METHODS AND REQUIREMENTS FOR INSTALLING NON-RESIDENTIAL UNDERGROUND ELECTRIC SERVICES		063928
	0 – 600 VOLTS TO CUSTOMER-OWNED FACILITIES		
Asset Type: Electric Distribution	Function: Design and Construction		
Issued by: Lisseth Villareal (LDV2) <i>Lisseth Villareal</i>	Date: 06–30–23		
Rev. #27: This document replaces PG&E Document 063928, Rev. #26. For a description of the changes, see Page 9.

**Methods and Requirements for Installing Non-Residential
Underground Electric Services
0 – 600 Volts to Customer-Owned Facilities**

Figure 1
Conduit Installation in a Drain Box

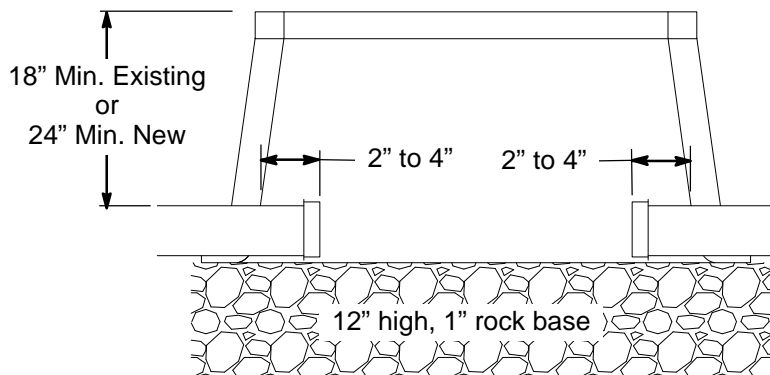
1. Revised Note 5C on Page 2.
2. Added new Note 6A on Page 2.
3. Revised Note 14E, 14E.1.a and revised text on Figure 1 on Page 3.
4. Revised Note 15 on Page 3.
5. Revised Notes 16A and 16E on Page 3.
6. Added Table Footnote 4 to Table 1 on Page 4 and to Table 2 on Page 5.
7. Adjust requirement for conduit strap installation. See Figure 3 on Page 8.

- (a) For 4" service conduit or smaller, install a 26" deep #2 enclosure, and enter through the short walls, making sure to maintain 18" minimum depth for existing installation and 24" for new installation from finish grade to top of the conduit. See Figure 1 below.

- (b) For 5" service conduit (up to 3 conduits), install a 26" deep #3 enclosure, and enter through the short walls, making sure to maintain 18" minimum depth for existing installation and 24" for new installation from finish grade to the top of the conduit. See Figure 1 below.

- (c) For either 14E(1)(a) or 14E(1)(b) box installation, install the enclosure on a twelve-inch base of, one-inch rock to aid in the drainage of the unwanted water, align the conduits at either end to achieve a nearly straight pull and install end bell fittings on all conduits.
